M/T - 6 Speed MTM Difficulty Selecting Gears
TRANSMISSION & [CLUTCH](#)
 TC002-01

Title:
 6-SPEED MTM

Models:
 '00 - '01 Celica GTS

Introduction

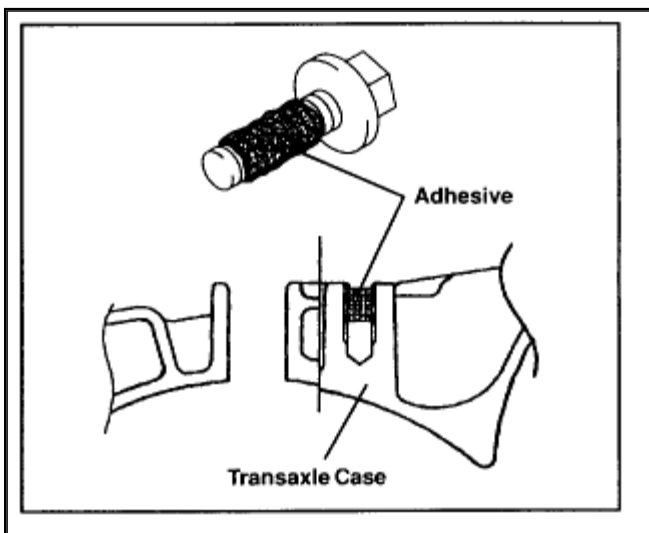
- B. Lightly apply 1344 sealer (P/N 0883-00080) to the bolt threads and the bolt hole on the transaxle case, as shown.
4. Install the speed sensor with the retaining bolt.

Torque: 11.3 Nm (115 kgf cm, 8 ft)

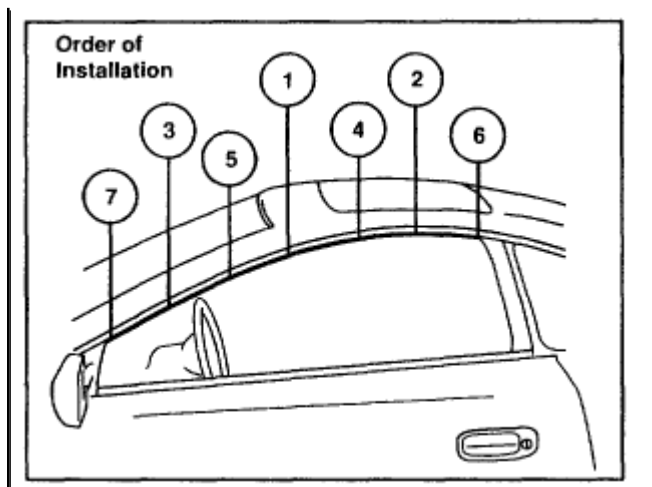
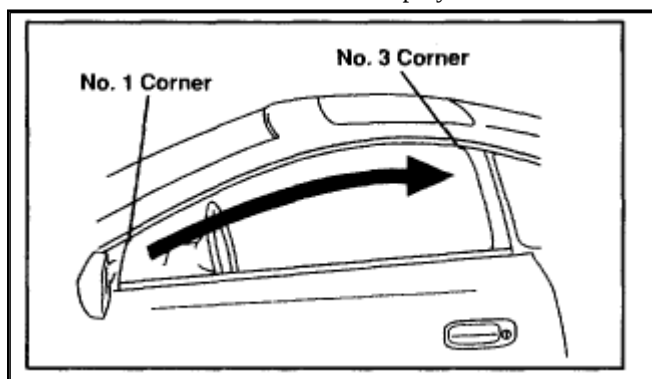
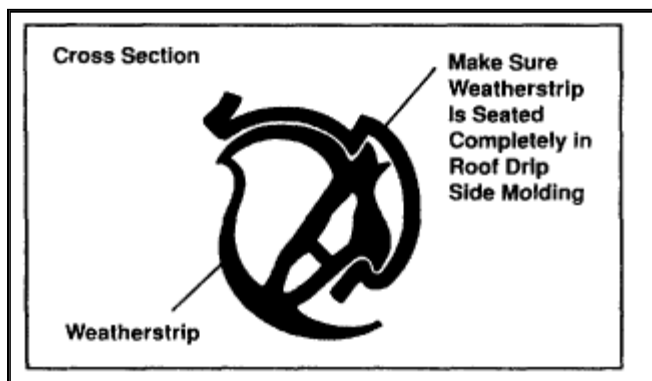
The installation method of the roof side rail weatherstrip has been modified to improve retention between the No. 1 and No. 3 corners on 2000 model year Celica vehicles. The part has not been changed. Use the following installation instructions to reinstall the roof side rail weatherstrip on vehicles with the above concern.

3. Hook the bottom edge of the weatherstrip into the roof drip side molding first. Then, using your fingers, install the top edge of the weatherstrip into the molding.

4. Continue to install the weatherstrip by hand in the order shown in the illustration.

5. Using finger pressure, press the length of the weatherstrip between the No. 1 and No. 3 corners to verify that the weatherstrip is seated completely in the roof drip side molding as shown in illustration.

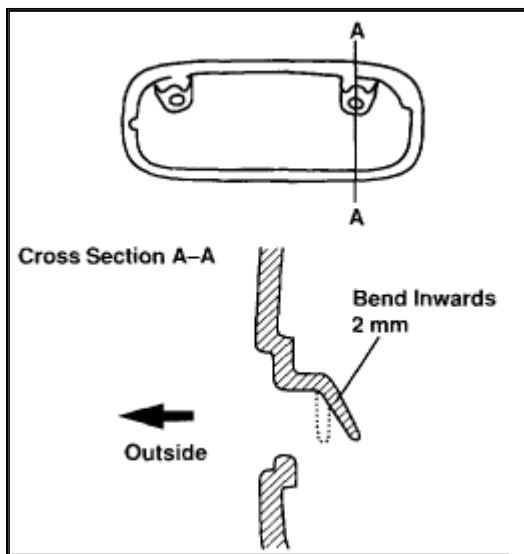
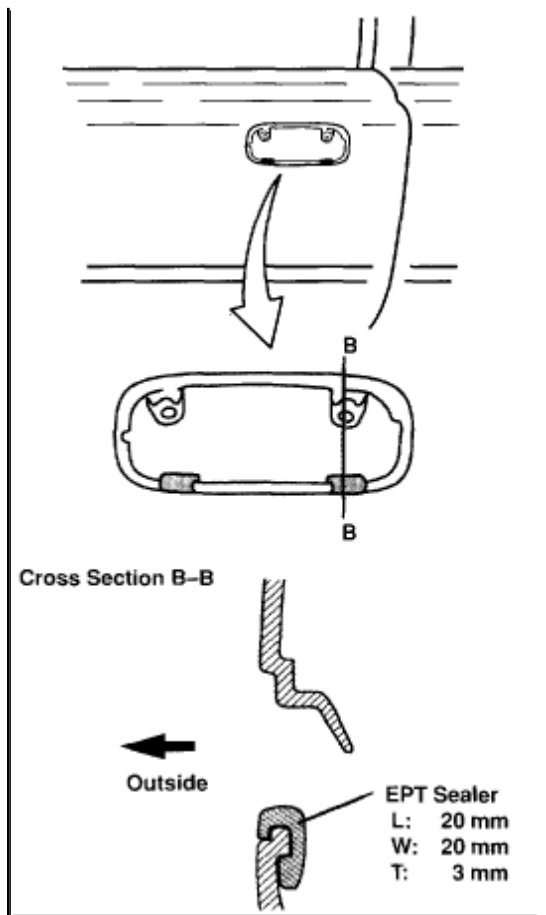
The outer [door handle](#) on some 2000 model year Celica vehicles may appear to be loose due to a gap between the door handle and door panel. A production countermeasure has been implemented. Use the following procedures to reduce outer door handle movement concerns.

7. Adjust both mounting tabs inwards 2 mm as shown in illustration.
8. If the outer [door handle](#) is still loose after adjusting the mounting tabs, install EPT sealer as indicated below:

Length:	Width:	Thickness:
20 mm	20 mm	3 mm

B. Install EPT sealer as shown in illustration.

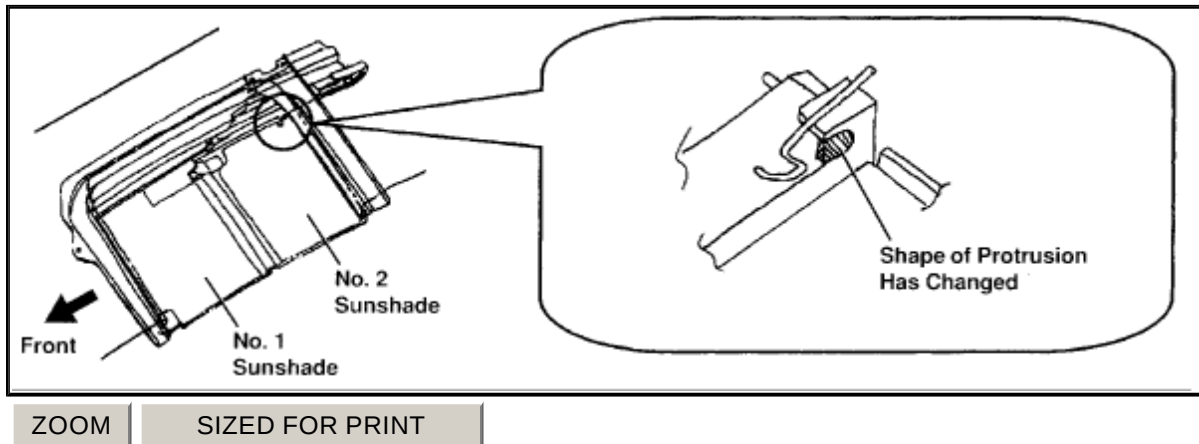
A change was made to the shape of the protrusions located at the left and right rear corners of the No.2 sunshade, as shown in the illustration above.

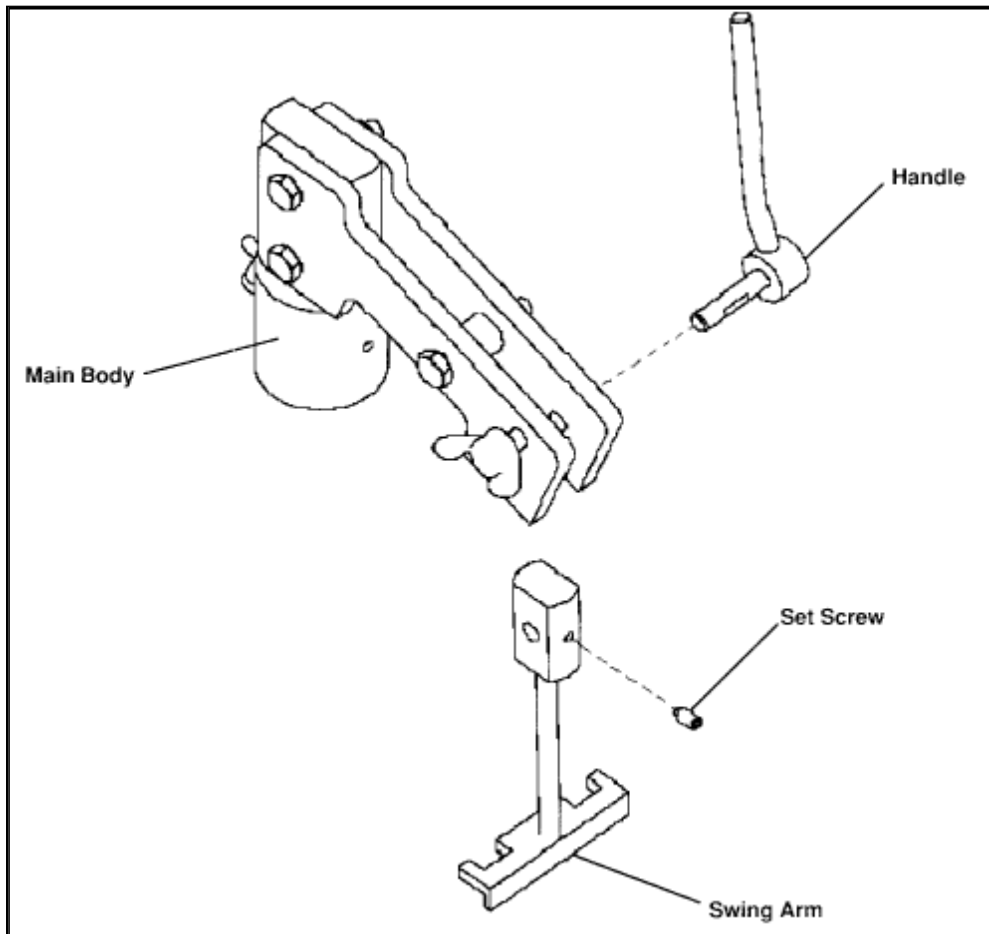
A revised design swing arm will replace the existing swing arm on the [Valve Clearance](#) Adjusting Compressor. This new swing arm is approximately 0.2" longer than the original and is zinc-plated for identification purposes.

1. Remove the 2 mm set screw from the swing arm using the Hex wrench supplied.
2. Remove the handle and the old swing arm; discard the old swing arm.
3. Install the new swing arm (P/N 09248-07010-ARM) and handle, making sure that the flat portion of the handle is aligned with the set screw prior to tightening.
4. Tighten the set screw using the Hex wrench supplied.
